Product Change Notice (PCN)

PCN Number: **PCN-0451185R-01**

Product(s) Affected: PJ-050B

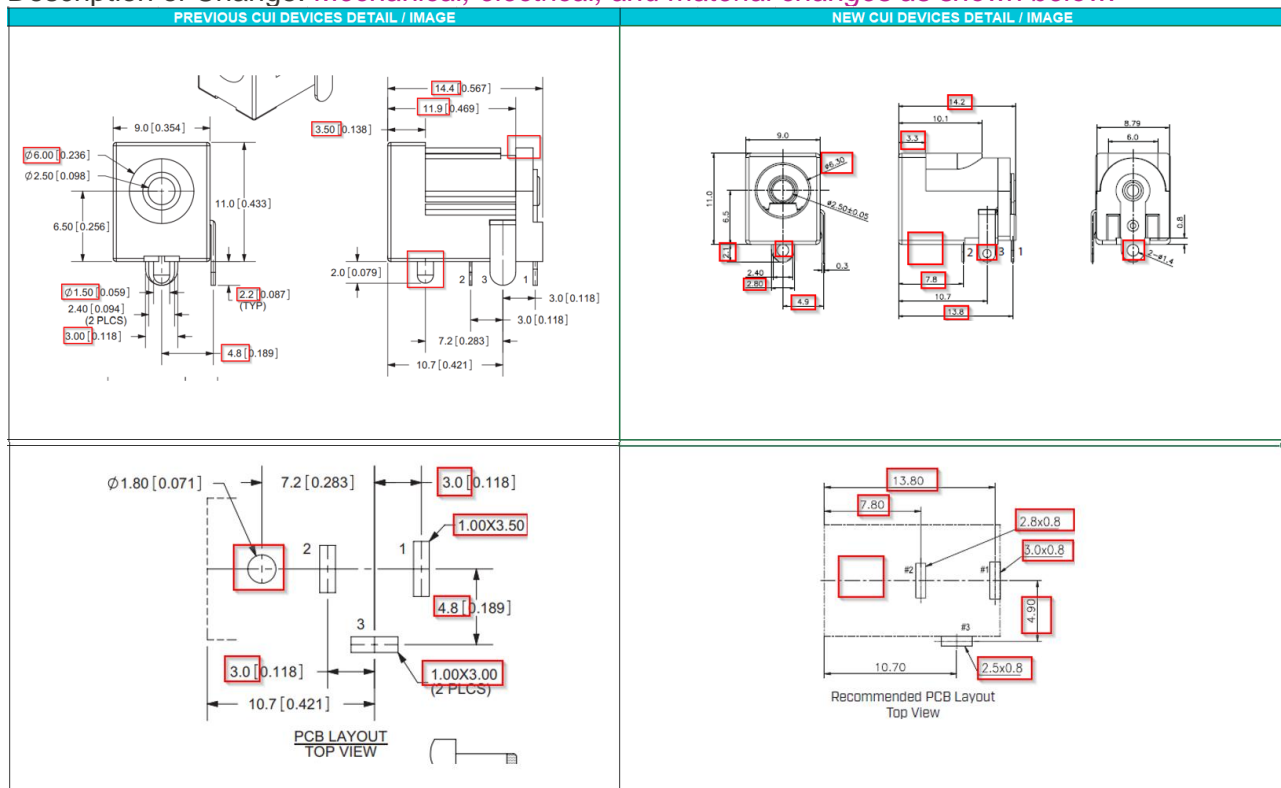
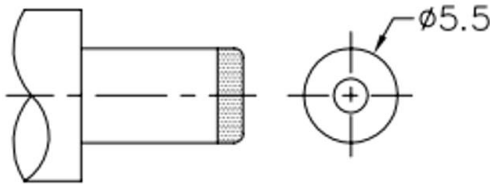
Description of Change: *Mechanical, electrical, and material changes as shown below:*

MATERIAL	PLATING
center pin	copper	nickel
terminal 1	brass	tin
terminal 2	copper alloy	tin
terminal 3	brass	tin
plastic	PBT

DESCRIPTION	MATERIAL	PLATING/COLOR
center pin	copper alloy (H65)	nickel
terminal 1	C2680 t=0.35	nickel-silver
terminal 2	C5210 t=0.25	nickel-silver
terminal 3	C2680 t=0.30	nickel-silver
cover	PA9T UL94V-0	black
housing	PA9T UL94V-0	black

MATING PLUG
Jack Insertion Depth: **8.5 mm**

MATING PLUG
Jack Insertion Depth: **9.6 mm**

Operating temperature range changing to -25C ~ +85C
